SERVICE INSTRUCTIONS

No. 0698-359 Rev. I
ATA Code 24-30

SUBJECT: ELECTRICAL - ALTERNATOR - MODIFICATION OF ALTERNATOR ATTACHMENT AND SECURITY OF WIRING

Figure 1. Installation of Link.

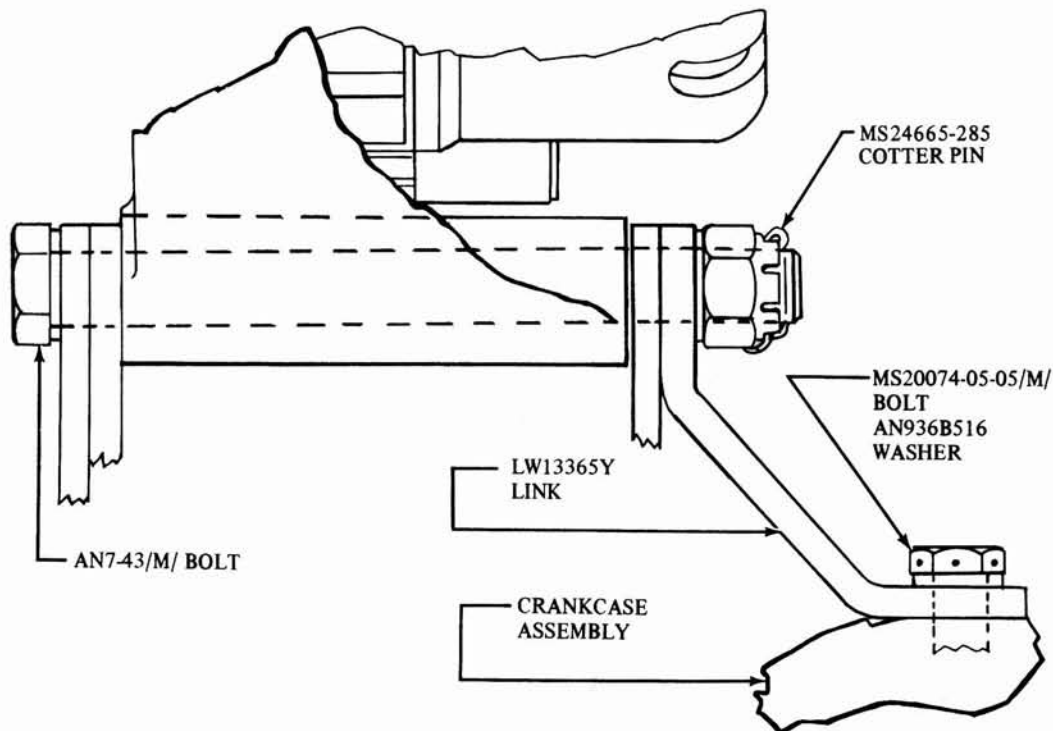
REASON: Provide an additional brace for the alternator and an improved attachment of the alternator wire.

DESCRIPTION: Add link to alternator mounting bracket and wiring clamp to alternator.

1. Remove the lower engine cowling.
2. Loosen the alternator drive belt and remove and discard the alternator mounting bracket bolt that attaches the alternator to the mounting bracket. Retain the nut and washers.
3. Attach the P/N LW13365Y link to the crankcase assembly using the MS20074-05-05/M/ bolt and AN936B516 washer as shown in figure 1.
4. Install the new AN7-43/M/ bolt with the existing nut and washer as shown in figure 1.
5. Before tightening the AN7-43/M/ bolt, check the drive belt tension using either of the following methods:

7. Install the MS24665-285 cotter pin through the nut and bolt as shown in figure 1.
